SERVICE BULLETIN

Title: MAST SUPPORT WIRE X 1250 INSPECTION

Identification	SB-011
Status	Active
Issue	1
Issue Date	30 October 2010
Applicability	X Series trike bases, all serial numbers unless previously accomplished.
Compliance	Mandatory

Figure 4 – Correct crimping.

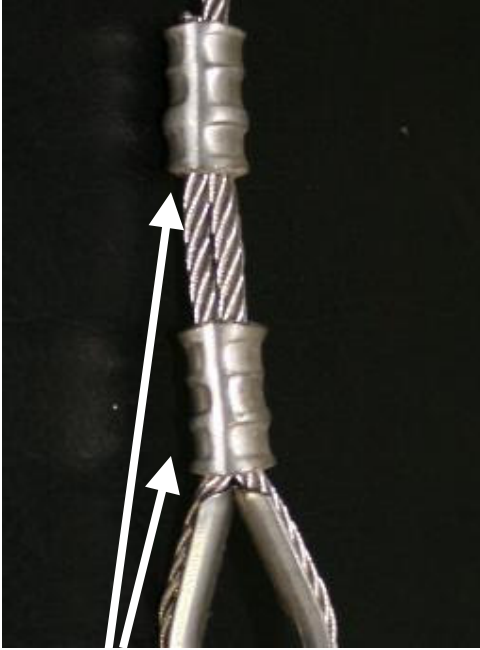
When the wire is crimped correctly the wire will pass completely through both crimps, will sit securely in the thimble, and the end of the wire will be visible at the top of the second crimp. Correctly swaged wires will be crimped so that all metal parts are compressed evenly, there are no large gaps on the inside of each swage, and there is no free play of the wire in the swage and no broken strands.

If corrosion, damaged wire, broken strands or incorrect crimping is observed the mast support wire needs to be replaced.

Figure 5 – Undo nut to remove wire at bottom.

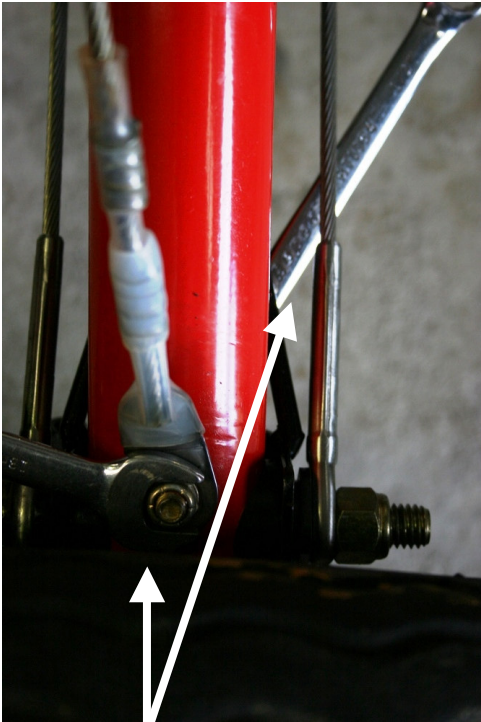
1. Apply the park brake.
2. Remove the wing from the base.
3. Lower the mast until the mast support wires go slack.
4. Use the two 1/2" spanners to undo the nut and release the wire tang at the bottom.

Figure 7 – Remove wire at left hand side top.

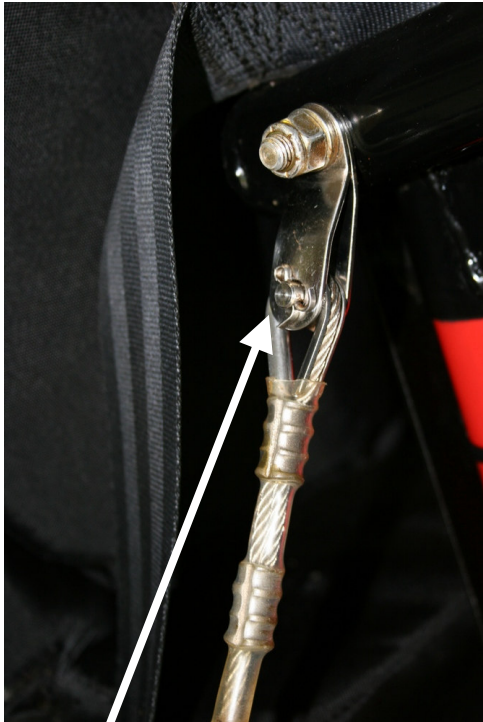
5. Use the pliers to close and remove the split pin, and remove the clevis pin to release the top of the mast support wire.
6. Replace the wire, the thimble end goes to the top. Use a new split pin when securing at the top. The split pin goes on the outside.
